STUDER A730

Einführung neuer Servoelektronik
Introduction of new Servo electronics

SI 150/91

Order Nr. 10.85.7260 (Ed. 1191)

MAIN BOARD 1.630.052.21 → 23
 DECODER / MODULATION DETECTOR SECTION

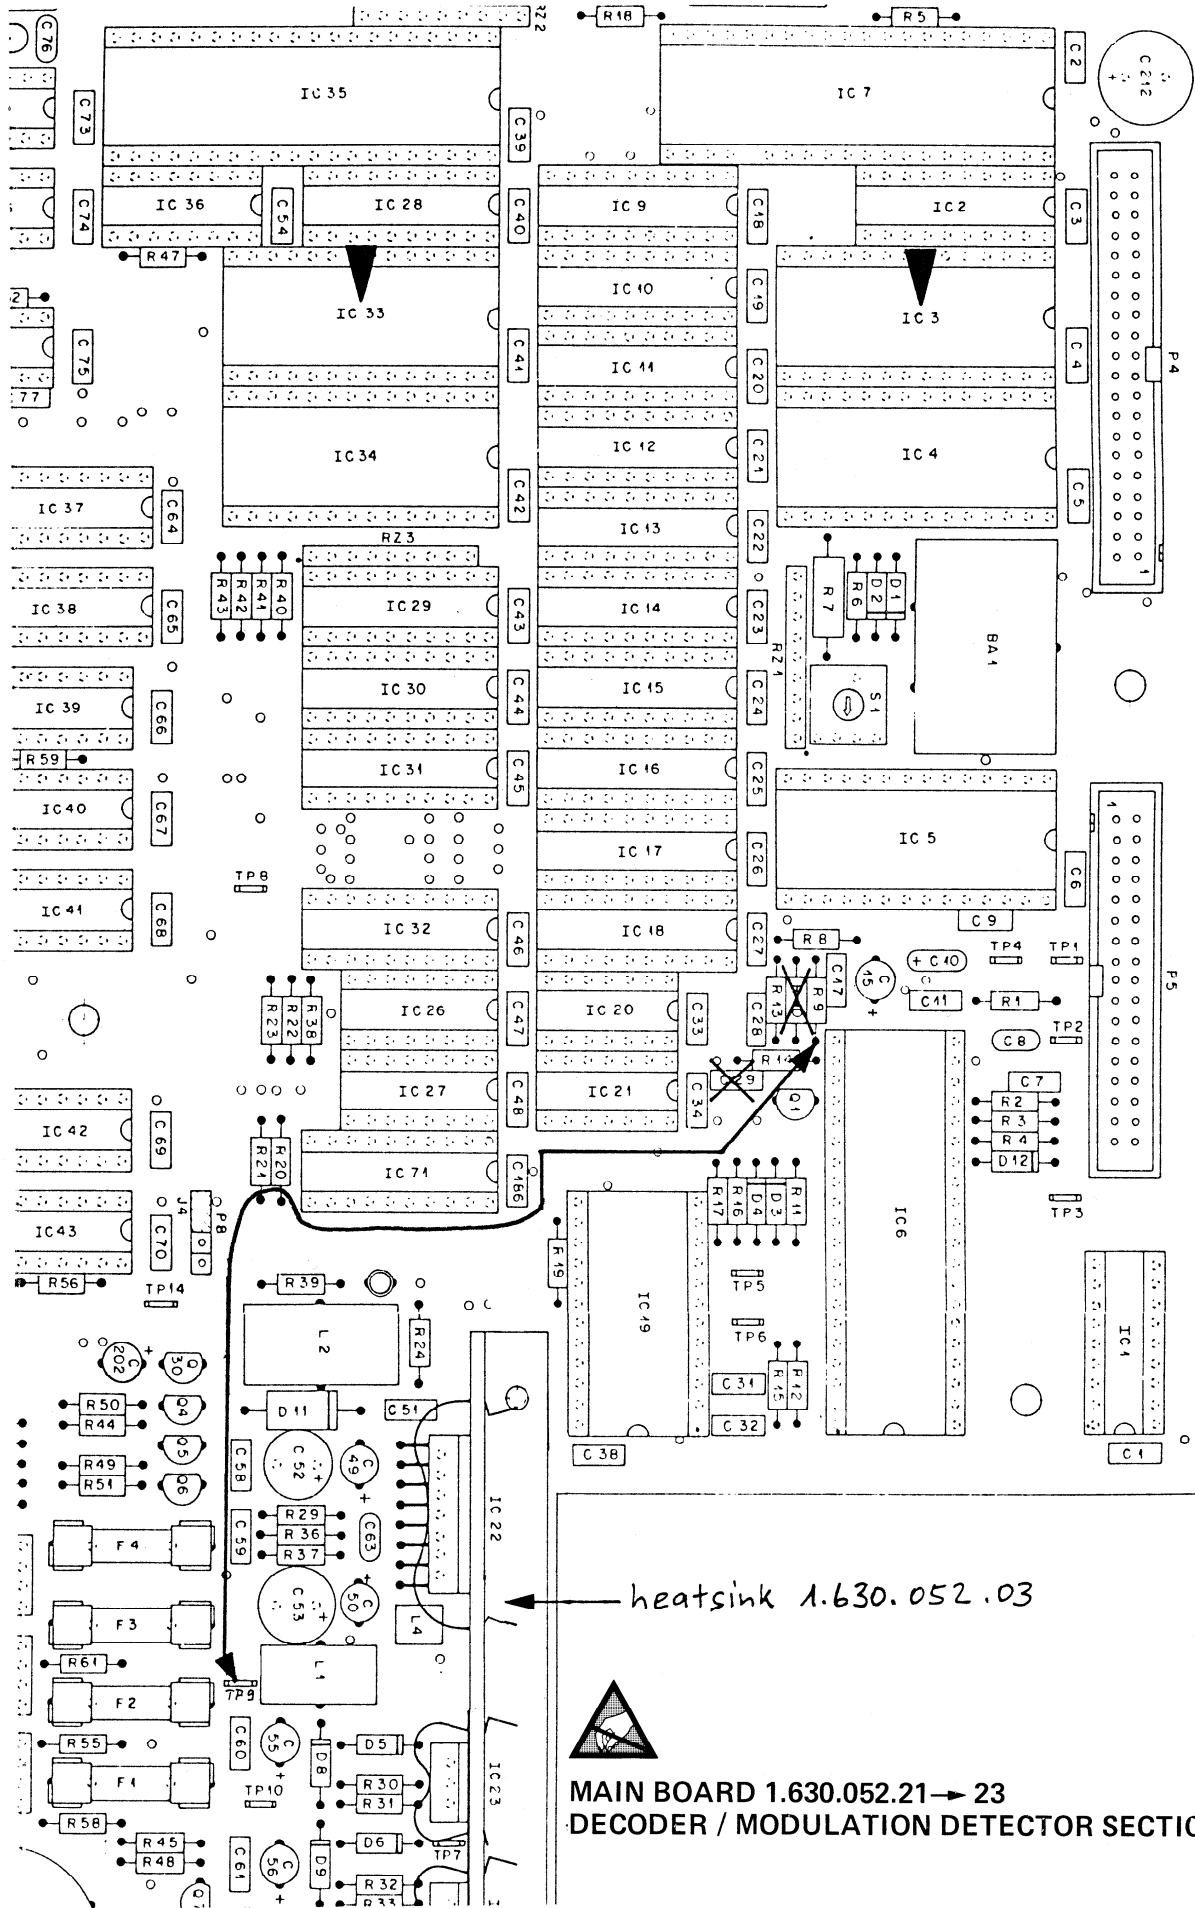
- MAIN BOARD aus dem Gerät ausbauen
- R10 (3k3) und C29 (22n) entfernen
- Folgende Bauteile werden geändert:

R1 (1k) wird ersetzt durch 2k2 (57.11.3222)
R8 (82E) wird ersetzt durch 39E (57.11.3390)
R14 (3k9) wird ersetzt durch 16k (57.11.3163)
R16 (680k) wird ersetzt durch 220k (57.11.3224)
R9, R13 und C28 inkl. wire wrap Draht sind vorgefertigt und müssen gemäss Fig. 1 und Fig. 2 auf Seite 18 eingebaut werden. Der Draht wird also auf TP9 (+12 V) geführt.

- Potentiometer R147 wird durch einen Widerstand 4k7 (57.11.3472) ersetzt --> grössere Verstärkung im Monitorpfad
- Am digitalen Ausgang wird ein Kondensator 1n2 (59.32.2122) zwischen die Pins 1 und 3 gelötet (Lötseite) --> Verminderung von Störstrahlung

- IC 3 (1.630.065.20) wird ersetzt durch 1.630.065.22 (CONTROL SOFTWARE)
- IC 33 (1.630.066.20) wird ersetzt durch 1.630.066.23 (SERVO SOFTWARE)

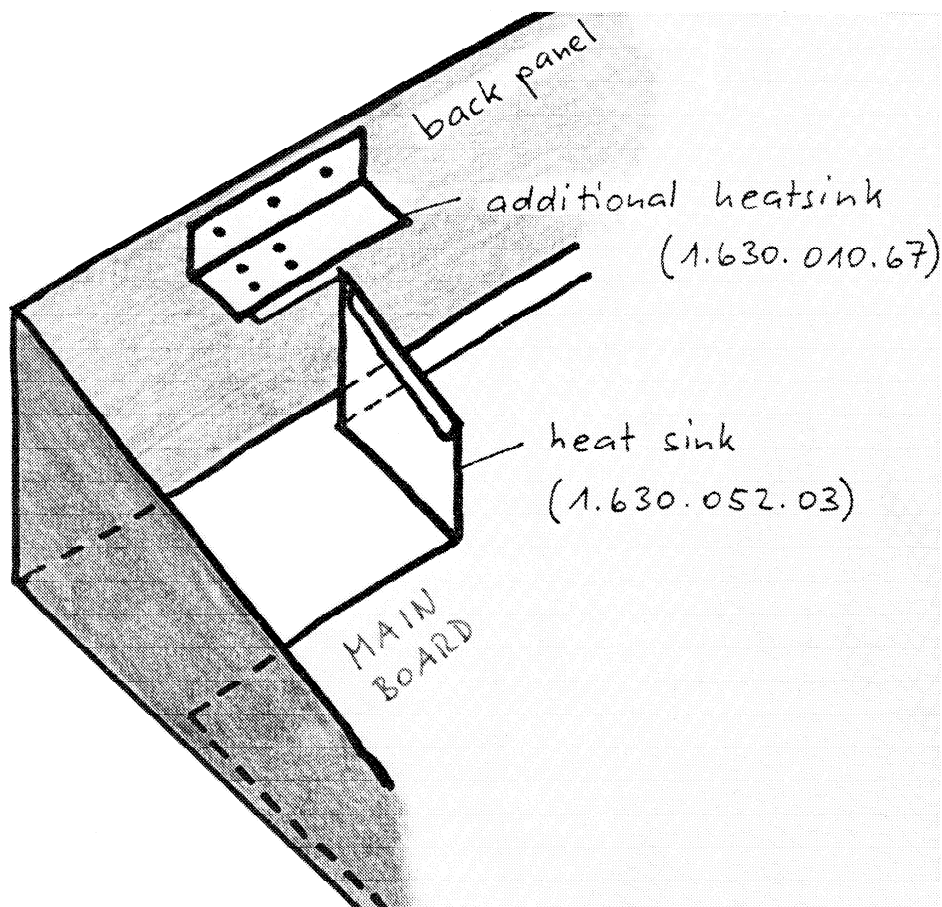
- Das Kühlblech (1.630.052.01) vom Board lösen (2 Schrauben, 4 Clips für Spannungsregler) und durch 1.630.052.03 ersetzen.
ACHTUNG: Auf festen Sitz der Clips auf dem Kühlblech achten!
- Mit der Bohrlehre (10.010.001.41) die 3 Bohrlöcher an der Rückwand des Gehäuses markieren. Anschliessend Bohrlehre entfernen und die Löcher (3.5 mm) bohren.
ACHTUNG: Bohrspäne restlos aus dem Gehäuse entfernen (wegen Kurzschlussgefahr)
- Kühlwinkel (1.630.010.67) und Kühlblech (1.630.052.03) miteinander verschrauben (Schrauben 21.53.0354). (Zwischen die Verbindungsstellen der einzelnen Blechteile ist etwas Wärmeleitpaste zu streichen). MAIN BOARD ins Gerät installieren und schliesslich den Kühlwinkel an der Rückwand von aussen mit den Schrauben (1.010.025.21) festziehen (siehe Zeichnung).

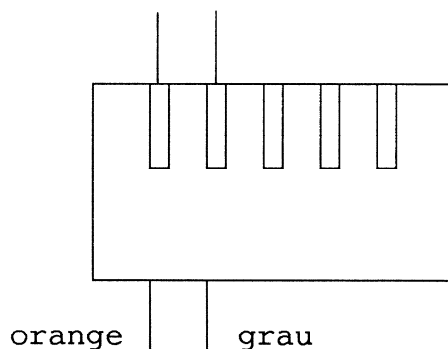
Auf der Bauteilseite wurde die 3-polige CIS-Buchse J4 durch eine 5-polige ersetzt.

Den grauen und den orangen Draht (Verbindung zum Verriegelungsmagneten) durch leichten Druck mit einem Schraubenzieher auf die Verriegelungsfahne im Stecker aus dem Steckergehäuse entfernen (siehe Skizze).

Verriegelungsfahne am grauen und orangen Draht wieder leicht zurückbiegen und ins 5-polige Gehäuse an den unten gezeichneten Positionen schieben, bis die Pins einrasten.

SERVO-BOARD 1.630.051.86

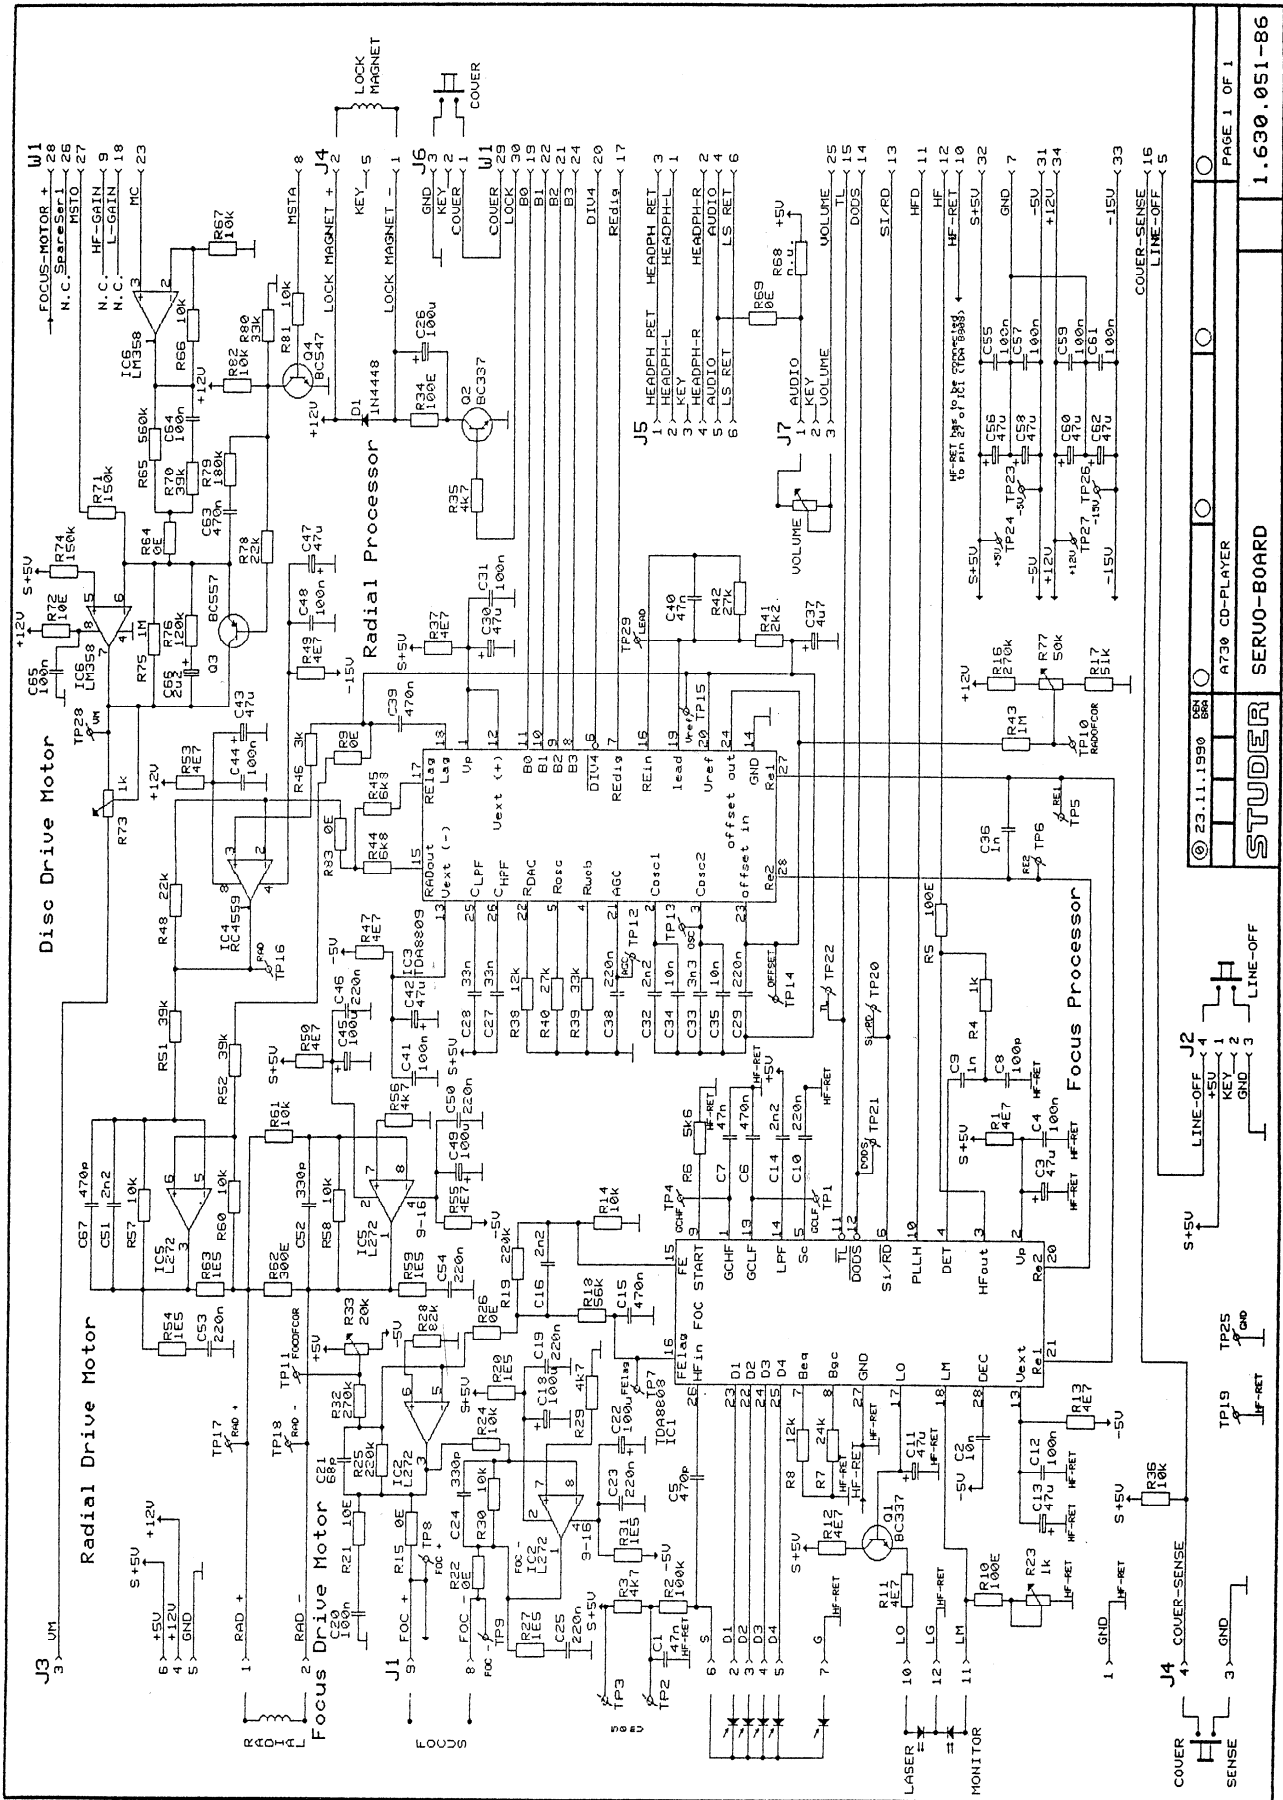
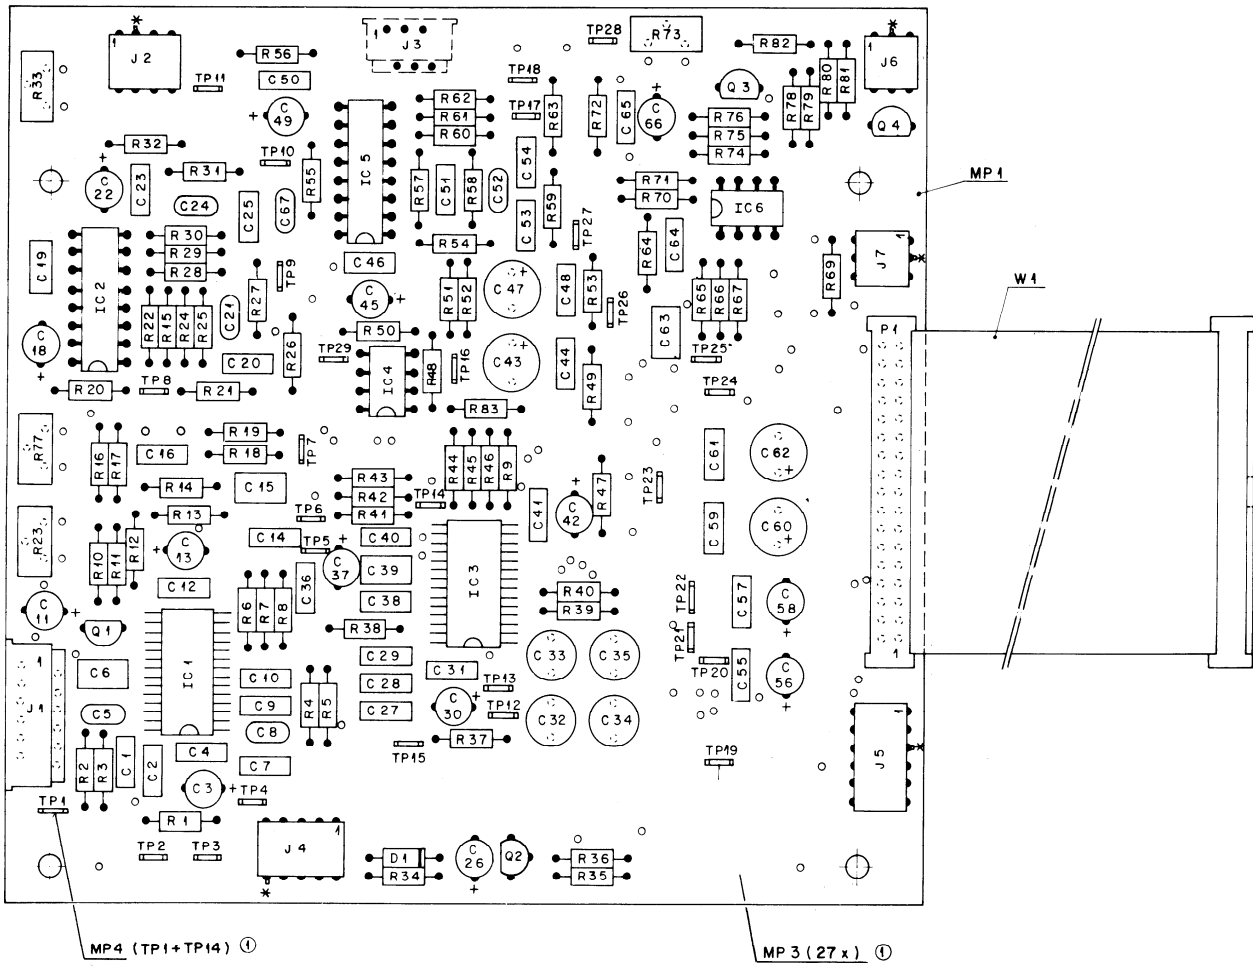
Alle früheren Versionen des SERVO BOARDS müssen durch die überarbeitete Version 1.630.051.86 ersetzt werden.

MAIN BOARD 1.630.052.21 → 23
 DECODER / MODULATION DETECTOR SECTION

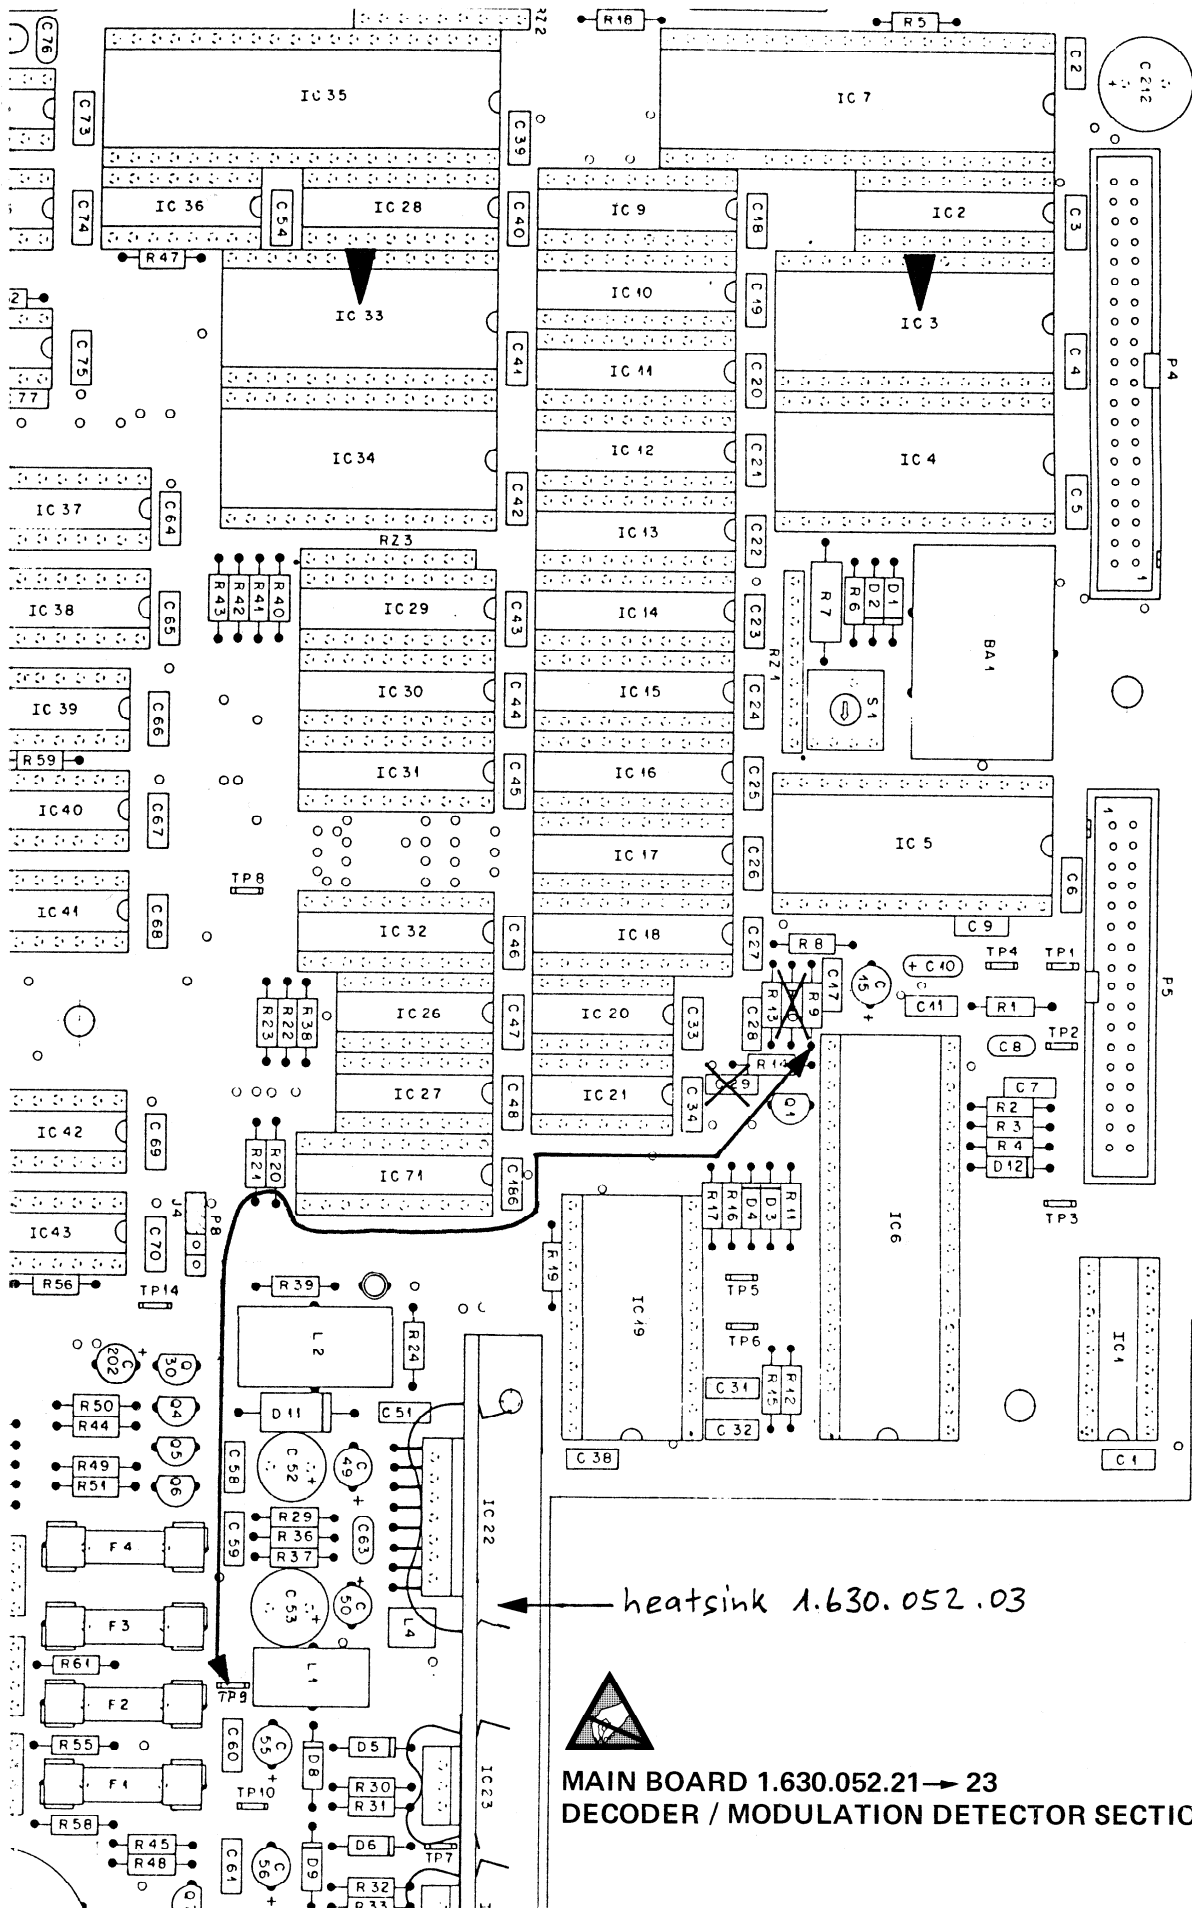
- Remove MAIN BOARD from the player
- Unsolder and remove R10 (3k3) and C29 (22n)
- The following components have to be changed:
 - R1 (1k) to be replaced with 2k2 (57.11.3222)
 - R8 (82E) to be replaced with 39E (57.11.3390)
 - R14 (3k9) to be replaced with 16k (57.11.3163)
 - R16 (680k) to be replaced with 220k (57.11.3224)
 - R9, R13 and C28 incl. wire wrap have been premanufactured and have to be installed acc. to Fig. 1 and Fig. 2 on page 17. The wire has to be connected to TP9 (+12 V).
- Replace potentiometer R147 by 4k7 resistor (57.11.3472) --> increased amplification in the monitor circuit
- Solder a capacitor 1n2 (59.32.2122) between pin 1 and 3 of the digital output (solder side) --> reduction of HF-emission

- IC 3 (1.630.065.20) to be replaced with 1.630.065.22 (CONTROL SOFTWARE)
- IC 33 (1.630.066.20) to be replaced with 1.630.066.23 (SERVO SOFTWARE)

heatsink 1.630.052.03

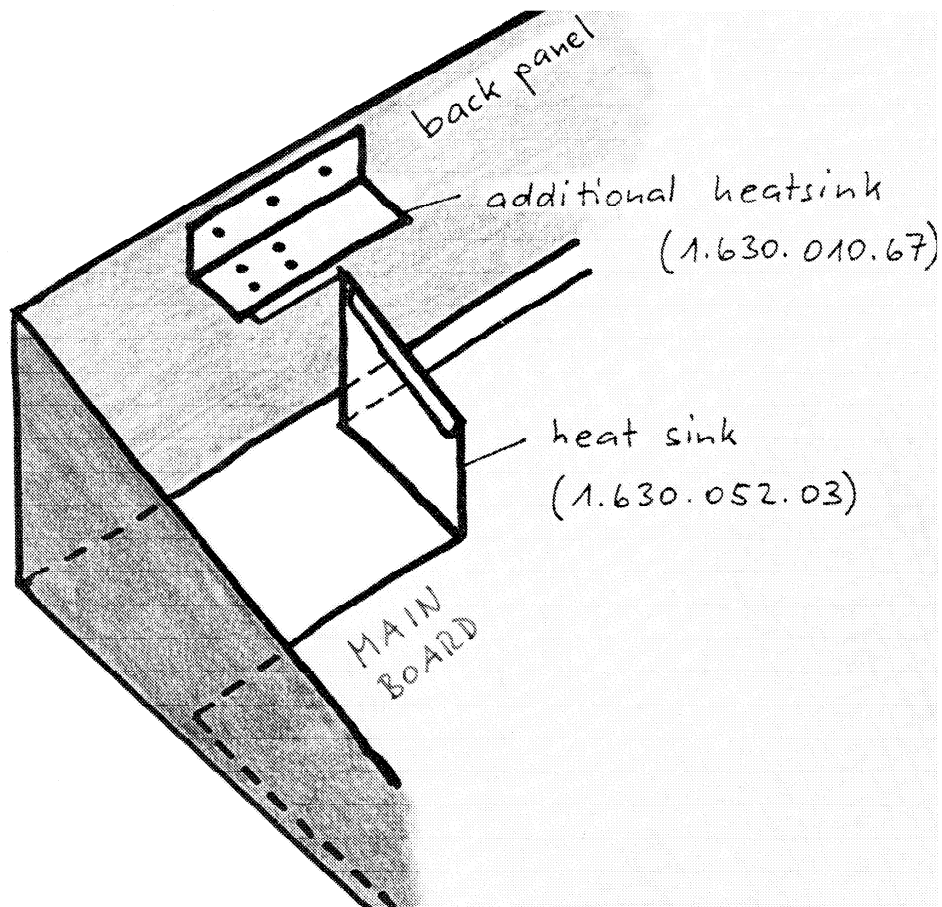
- Remove heat sink (1.630.052.01) from the print (2 screws, 4 clips for voltage control) and replace with 1.630.052.03.
ATTENTION: Ensure tight seating of the clips on the heat sink!

- Using drilling template (10.010.001.41) mark the 3 holes on the rear wall of the case. Then remove drilling template and drill the holes (3.5 mm).
ATTENTION: Make sure to remove all drilling chips from the case to avoid the risk of short circuits.

- Screw heat sink (1.630.010.67) to heat sink (1.630.052.03) with screws 21.53.0354. (Apply thermal joint compound at the points of contact between the heat sinks). Reinstall MAIN BOARD into player and fasten the small heat sink 1.630.010.67 to the rear wall with screws (1.010.015.21) from the outside (refer to drawing).

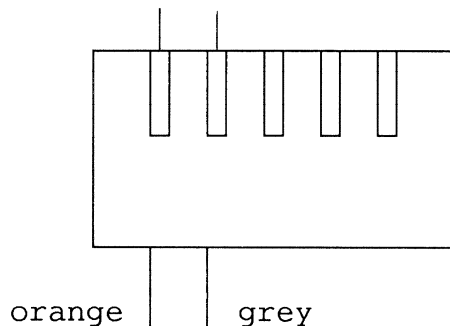
On the component side, the 3-pole CIS-socket J4 was replaced by a 5-pole socket.

Pull the grey and orange wires (connection to the lock-solenoid) from the plug's shell by slightly pressing down with a screw driver the locking tongues of each wire (see drawing).

Bend the locking tongue of the grey and orange wire into their original position and put them according to the drawing below into the 5-pole plug-shell. Make sure the pins are locked.
